Determination 2015/069

Determination regarding the compliance of retrofitted metal sill flashings to timber windows and doors installed in a 132-year-old house at 17 Hepburn Street, Freemans Bay, Auckland

2.3.2 The installation of consented windows is shown in Figure 1.

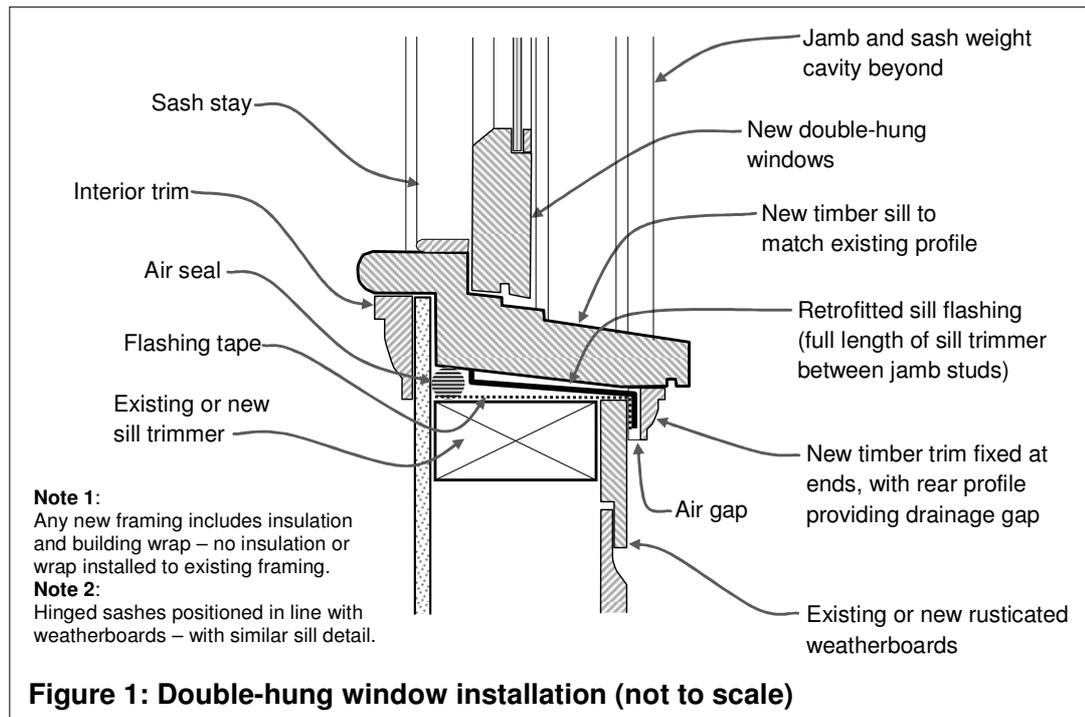
- 2.3.3 The retrofitted metal sill flashings extend the full length of the framed openings; with the ends terminating against the flexible flashing tape where it turns up against the jamb trimmers. The jambs are shown in Figure 2.
- 2.3.4 The replacement windows were installed within original window openings. A total of ten double-hung windows were apparently replaced, and sashes were replaced in a further seven windows with the existing window frames left in place.

- 6.4.1 The expert used a BRANZ sill detail for timber windows⁹ as a benchmark against which to assess the likely performance of the installed windows because it described ‘similar construction and was published by an accredited third party.’
- 6.4.2 The expert assessed differences between the as-built sills (see Figure 1) and the BRANZ detail, and commented as follows (in summary with BRANZ detail features shown in brackets):

Differences	Expert’s comments
The turn-down over the weatherboards is about 20mm (35mm noted in detail)	Flashing protected by moulding more than 35mm high, providing equivalent protection.
Not fitted to low risk situation (detail notes E2/AS1 restriction for direct-fixed weatherboards to low risk)	The associated features leading to a moderate risk score remain unchanged, but history of use of original windows indicates adequate in-service performance within those circumstances.
No building wrap to most locations (building wrap shown in detail)	Original weatherboards have performed over many years and are unchanged so can be expected to continue to do so.
Sill flashing slope is minimal (detail shows slope but no minimum noted)	Providing there is some slope and no back slope, flashing should drain adequately.

- 6.5.1 The expert concluded that the sill fitted with the retrofitted sill flashing is likely to comply with the relevant parts of Clause E2 and B2 providing:
- all sill flashings have been retrofitted in the same manner as the trial flashing
 - the sill flashings extend beyond the jamb reveal of the window frame
 - the sill flashings slope to the outside.
